# **Central Planning Authority**

**Minutes of a meeting of the Central Planning Authority held on March 17, 2021 at 10:00am, in Conference Room 1038, 1<sup>st</sup> Floor, Government Administration Building, Elgin Avenue.**

**CPA/06/21**

Figure 8. The applicant is proposing to increase the area of neighbourhood commercial space while bypassing the appropriate application procedures for a rezone.

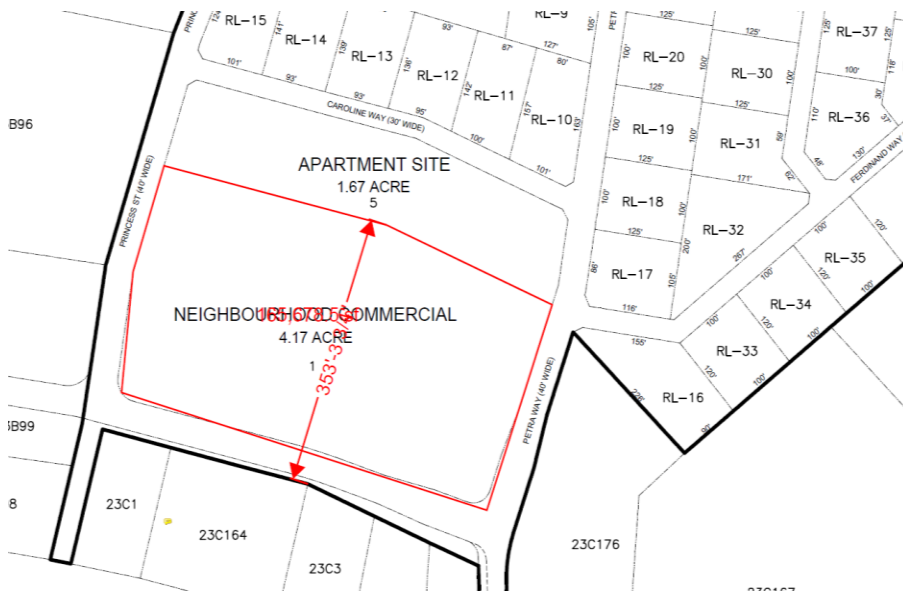
Overall, a modest change to the alignment of the road would protect the amenity of the pond for the adjacent landowner and provide benefits to the subdivision itself.

Figure 2: LIS 2018 Aerial image overlaid with site plan (Source: Roland and Bodden 23 Sept 2020)

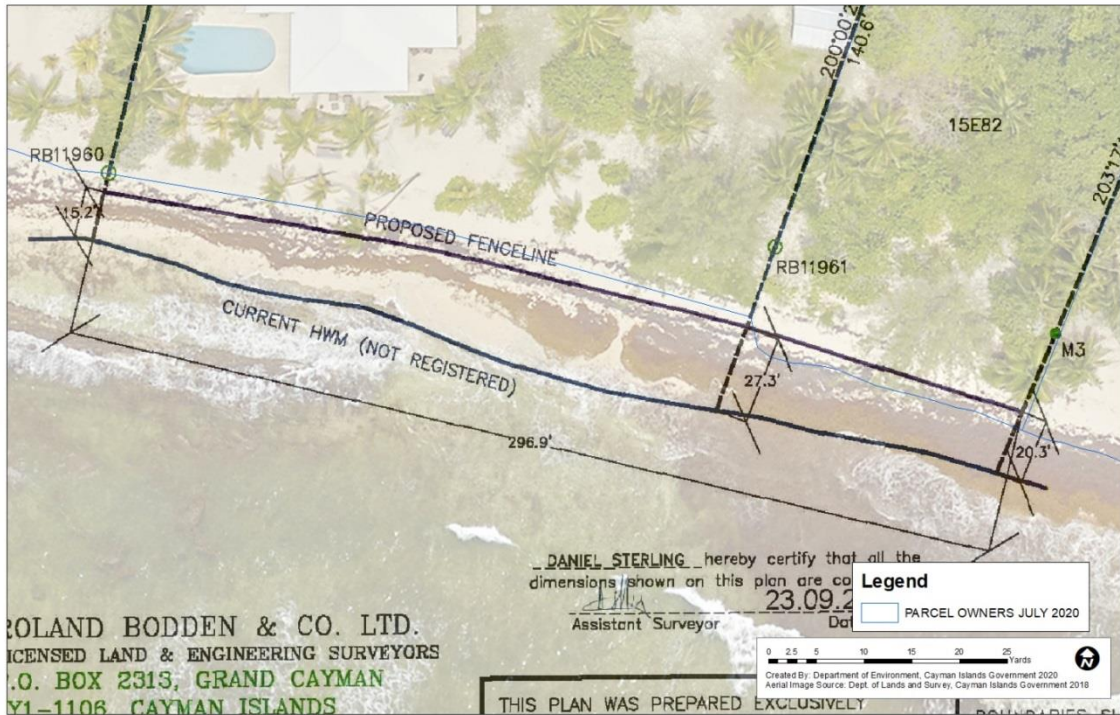
The site plan submitted (Drawing Ref: 15E238SiteMap.dwg) when overlaid onto the

*aerial imagery (see Figure 2) shows that the proposed fence line is position seaward of the current registered MeanHigh Water Mark survey, even though the most recent survey (which is not registered) as depicted by the site plan is seaward of the proposed fence line. This illustrates that the beach is extremely dynamic.*

- *The fence should be moved further landward behind the existing beachside vegetation and the registered Mean High Water Mark as shown in Figure 1 (the blue line). The existing vegetation represents the boundary of the most recent erosion cycles and consequently behind it the beach is most stable.*

Figure 3: Geo-referenced application plan (Nov 2020) overlaid on Google imagery (May 2020). (Source: Olsen & Associates, 2021).

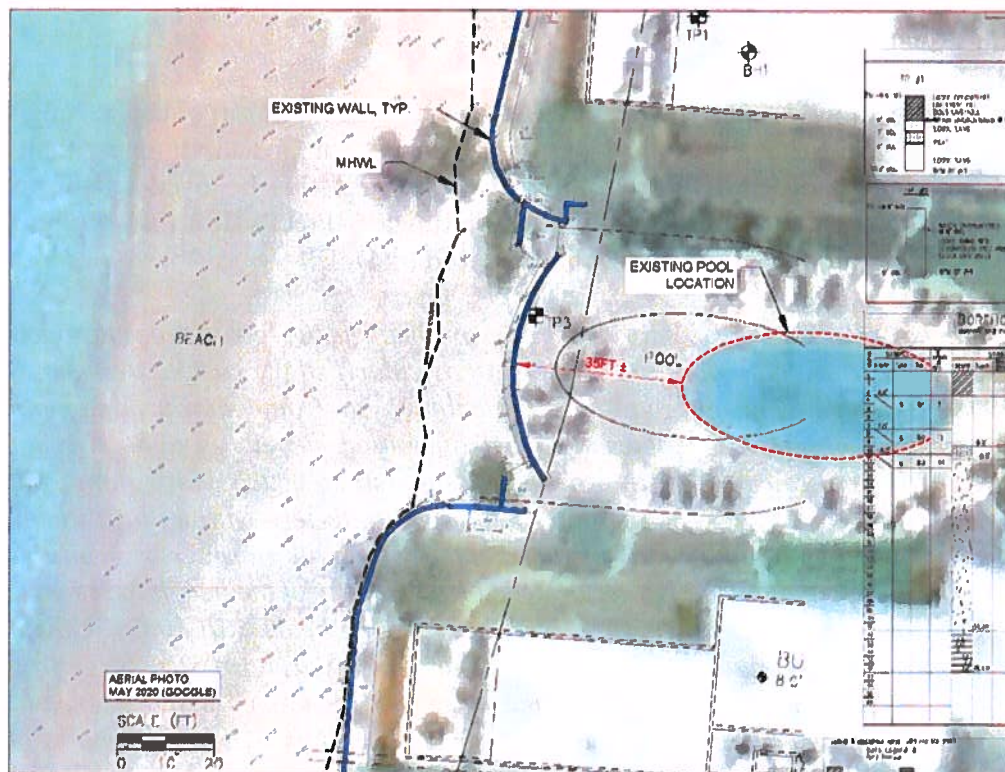
After geo-referencing the application plans, it was identified that the existing pool is incorrectly depicted as being about 35 feet closer to the seawall than it actually is (see Figure 3). We tried to clarify this situation with the applicant’s agent, but to-date no response has been received. Additionally, Olsen & Associates noted that the graphic scale on sheets C-201 and C-202 is incorrectly labelled (it appears correct on the left side of ‘0’, but incorrect on the right side of ‘0’), and the location of the existing seawalls (and/or demolition plan, as applicable) is not shown in the Sections, sheet C-300. [See Figures 6 & 7.] Olsen & Associates note that these discrepancies are important for the following reasons:

*“(1) The plans, as-drawn, suggest that there is little or no space to provide beach access or seawall re-construction between the pool and the existing seawall. However, when examined in actual existing conditions [Figure 4], there is about 35-ft space between the pool and the wall.*

*(2) The plans, as-drawn in section, do not clarify where the new repaired wall shall be built upon the beach relative to the existing walls. In planform view, it appears that the repaired wall locations will be at or very near the existing locations; but this is not specifically indicated. Clarification of same would be important to a permit document”.*

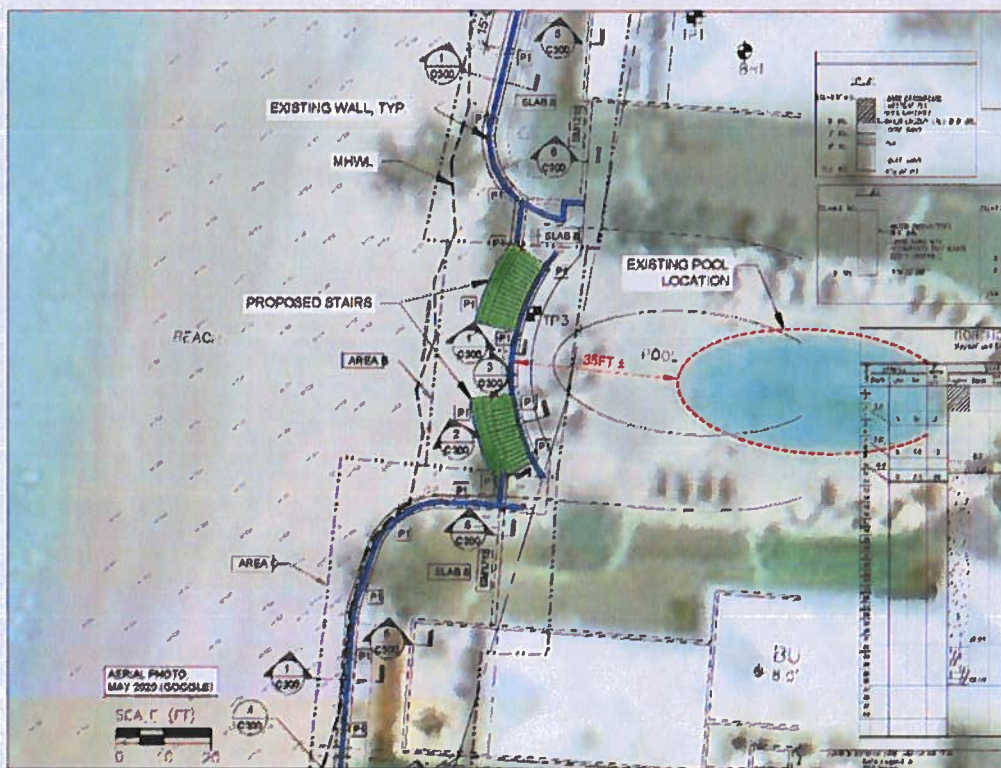
**Figure 4** depicts the existing structure condition along the central project area, reproduced from the plans – with the existing seawall highlighted in blue. **Figure 5** depicts the proposed structure improvements, reproduced from the plans – with the seawall in blue and new stair structures in green, based on our understanding of the plans. **Figure 6** is the cross-section of the proposed seawall repair/replacement, typical. **Figure 7** is the cross-section of the newly proposed beach stairs, seaward of the existing pool deck seawall, reproduced from the plans.

There is some error and ambiguity in the drawings which required discernment. The graphic scale on sheets C-201 and C-202 is incorrectly labelled. (It is apparently correct on the left side of ‘0’, but incorrect on the right side of ‘0’, after some study). The existing pool is incorrectly depicted as being about 35 feet closer to the seawall than actual. [See **Figures 4 & 5.**] The location of the existing seawalls (and/or demolition plan, as applicable) is not shown in the Sections, sheet C-300. [See **Figures 6 & 7.**]

Figure 6: Seawall repair section, reproduced from plans.

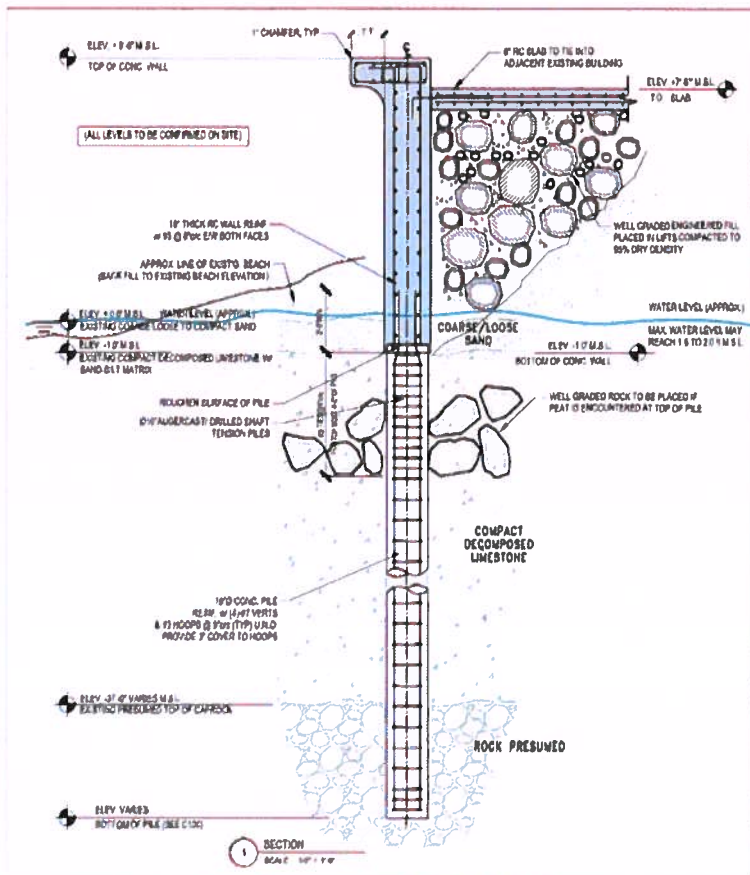
These discrepancies are important for the following reasons. (1) The plans, as-drawn, suggest that there is little or no space to provide beach access or seawall re-construction between the pool and the existing seawall. However, when examined in actual existing conditions [**Figure 4**], there is about 35-ft space between the pool and the wall. (2) The plans, as-drawn in section, do not clarify where the new repaired wall shall be built upon the beach relative to the existing walls. In planform view, it appears that the repaired wall locations will be at or very near the existing locations; but this is not specifically indicated. Clarification of same would be important to a permit document.
